**U.S. DEPARTMENT OF ENERGY (DOE) RESPONSES TO COMMENTS IN THE STATE OF NEVADA'S
MAY 30, 1989, LETTER ON THE EXPLORATORY SHAFT FACILITY (ESF)**

RESPONSES TO STATE OF NEVADA LETTER ON THE SITE CHARACTERIZATION PLAN/ EXPLORATORY SHAFT FACILITY

U.S. DEPARTMENT OF ENERGY RESPONSES TO THE PRELIMINARY
COMMENTS RECEIVED FROM THE STATE OF NEVADA
ON THE SITE CHARACTERIZATION PLAN

Figure 1. Inferred faults in the Coyote Wash area as interpreted by Smith and Ross (1982).

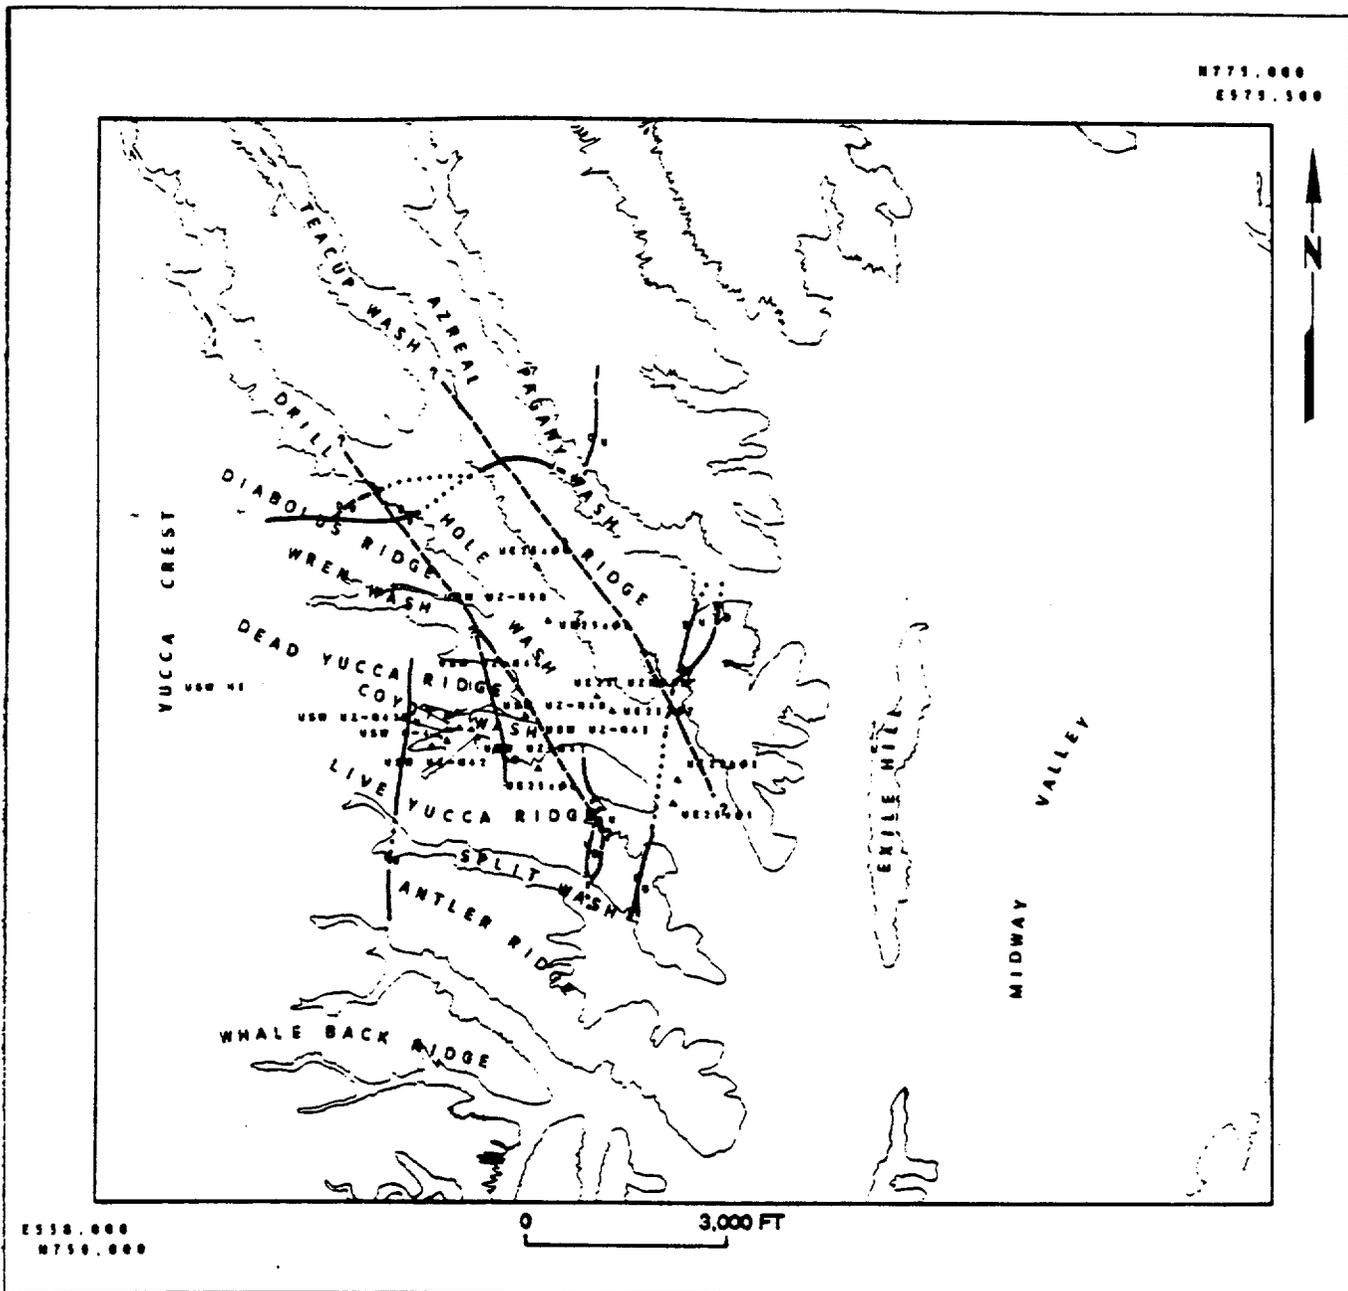
In addition to the fault/fracture zone inferred in Drill Hole Wash, Smith and Ross (1982) inferred the presence of a minor normal fault in Coyote Wash (Figure 1). This inferred fault was located about 400 meters (1,300 feet) east of Ghost Dance fault and was inferred to be downthrown to the east.

Figure 2. Faults interpreted from resistivity data by Hoover, mapped faults shown by Lipman and McKay (1965), locations of resistivity lines.

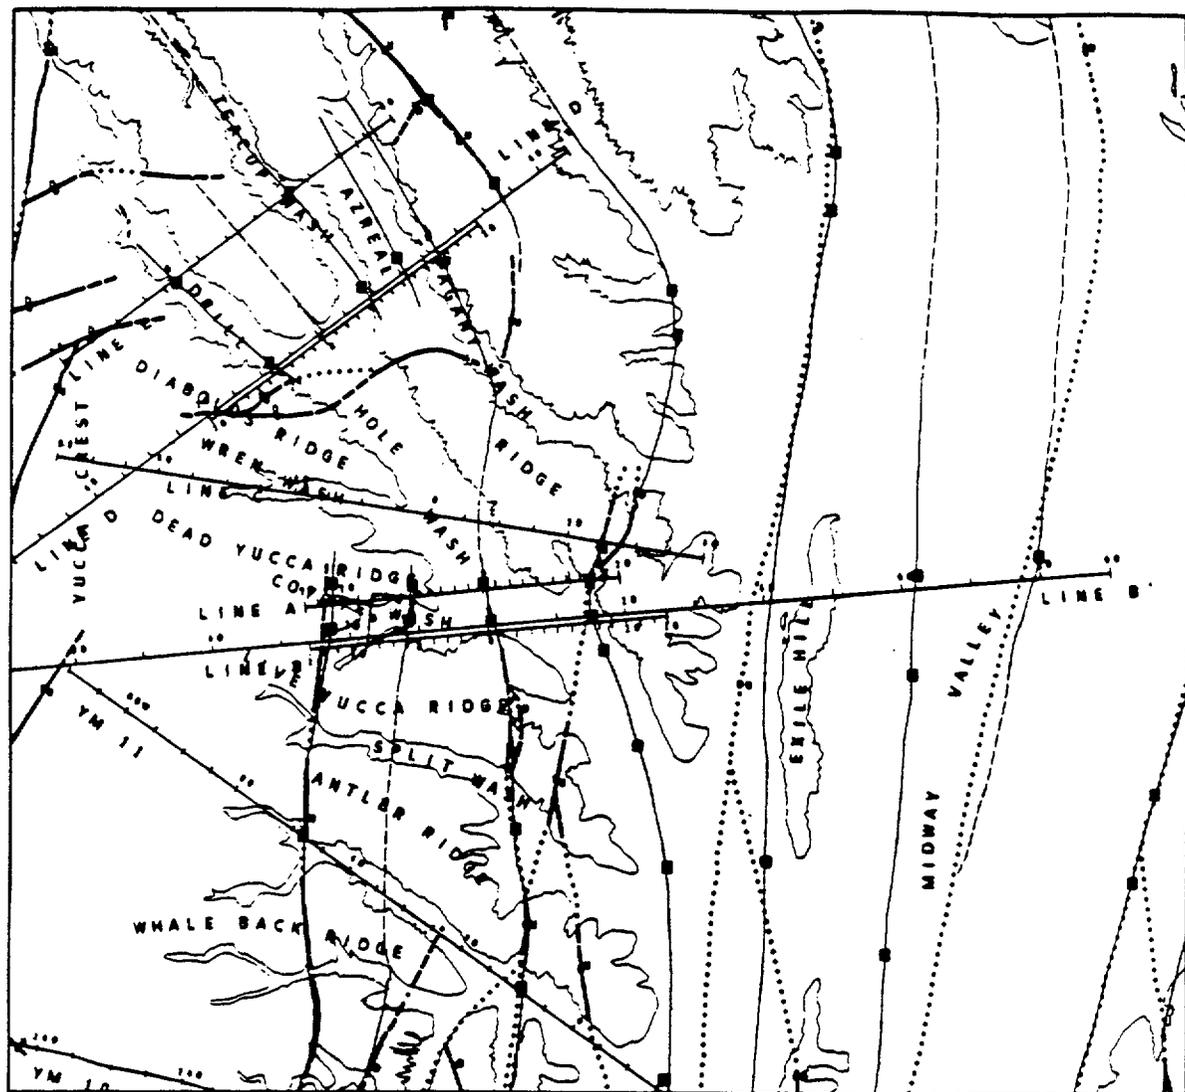
The Open File Report figure is apparently based on an unpublished interpretive map of published and unpublished electrical resistivity data compiled by D.B. Hoover. This unpublished map indicates that the location of the northern end of this longer fault cutting Coyote Wash is based on the interpretation of Smith and Ross (1982). Hoover used a dashed line to connect the inferred fault in Coyote Wash with another fault inferred to cross unpublished resistivity line YM10 at a point about 7,500 ft south of

Coyote Wash (Figure 2). The location of the inferred fault cutting line YM10 coincides with a fault mapped by Lipman and McKay (1965), which trends to the northeast of the hypothesized connection between the inferred resistivity faults and terminates near Whale Back Ridge (Figure 2). However, in the figure that appears in the Open File Report (USGS 1984) and the SCP, the dashed line connecting the two inferred fault segments has been replaced by a solid line (Figure 3). This appears to represent a drafting error in the preparation of the published figure since other dashed lines shown on the unpublished version of the map were generally deleted from the published map.

Figure 3. Faults interpreted from electrical resistivity data as shown on Figure 32 of U. S. Geological Survey Open File Report 84-792 and in SCP Figure 1-40.

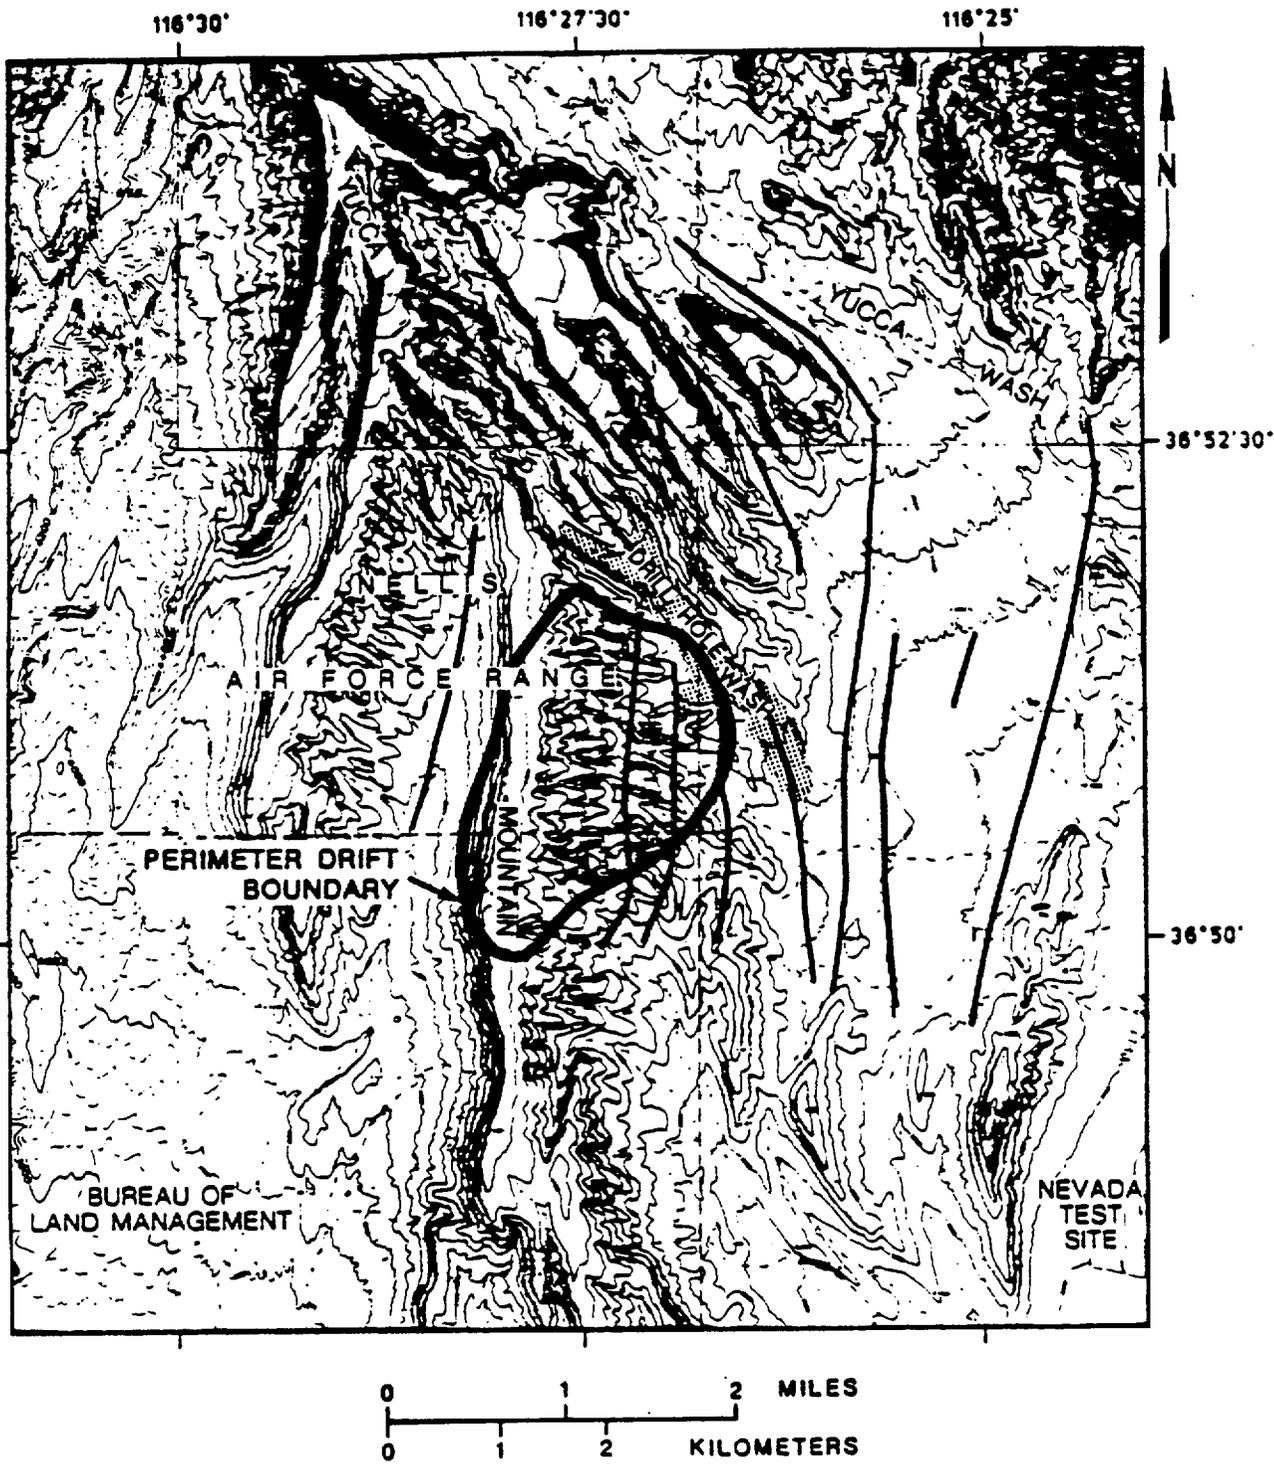
USGS Open File Report 84-792 (USGS, 1984) is a compilation and interpretation of geologic data on the Yucca Mountain region acquired before January 1, 1983. The report was used as a source in the preparation of the geologic descriptions of Yucca Mountain for the Environmental Assessment (EA) (DOE, 1986) and the Site Characterization Plan (SCP). Figure 32 of the Open File Report shows a map of "Faults and (or) fractures at Yucca Mountain interpreted from electrical resistivity data." The text of the Open File Report does not give any additional information on the source of this interpretation. The same figure was also duplicated in the SCP as Figure 1-40. This figure shows a fault in Coyote Wash at the location where a fault was inferred by Smith and Ross (1982), but also shows the fault extending much farther to the south than Smith and Ross indicated.

Figure 4. Location of faults shown by Scott and Bonk (1984) and siting area and shaft locations recommended by Bertram (1984).

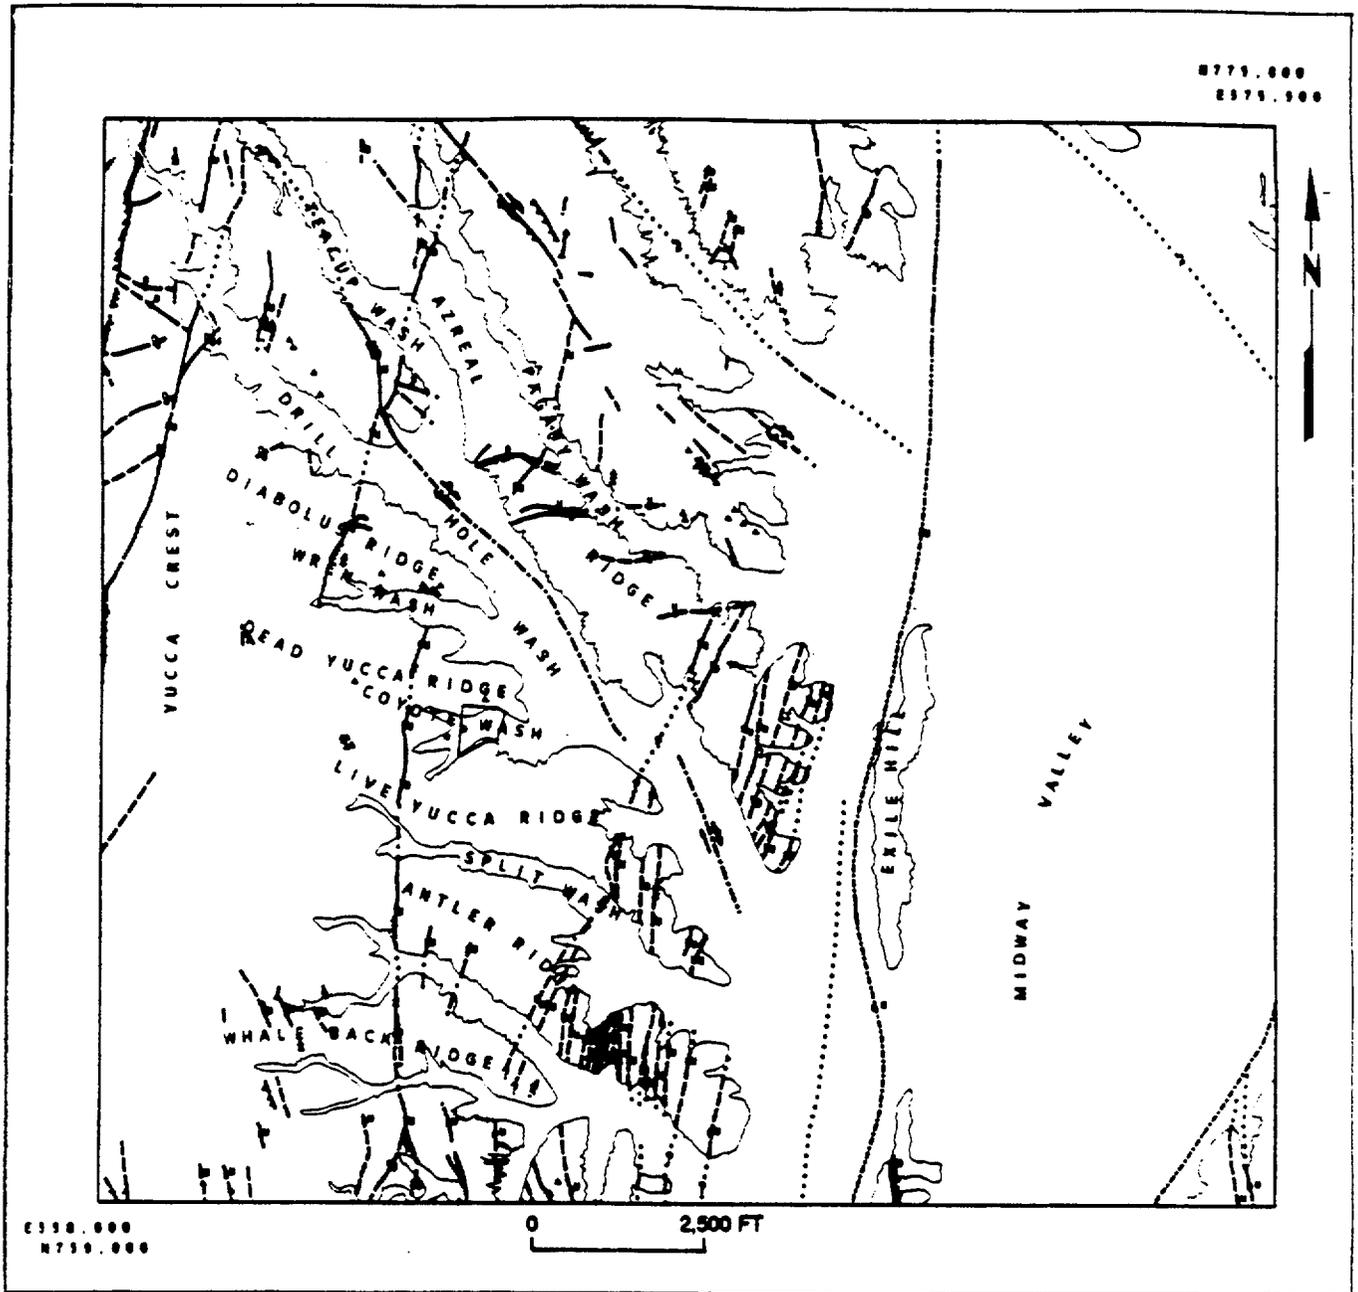
A map identifying potentially adverse structures was prepared using a preliminary version of the Scott and Bonk (1984) map as a source (Spengler, oral communication). The only potentially adverse structure identified on this map in the Coyote Wash area was the Ghost Dance fault (Figure 4). One Ad Hoc TOC committee member was aware of the report by Smith and Ross, but was of the opinion that the Scott and Bonk mapping was more reliable because topographic effects may have affected the resistivity/IP survey and the interpretation of Smith and Ross was not confirmed by the drilling program in Drill Hole Wash. Also, the main concern at the time was to identify significant throughgoing structures; apparently minor features, such as the fault inferred by Smith and Ross (1982) in Coyote Wash, were not considered in shaft selection because they had no mapped extent. Therefore, the faults shown in the Smith and Ross (1982) report in Coyote Wash were not considered to be potentially adverse structures.
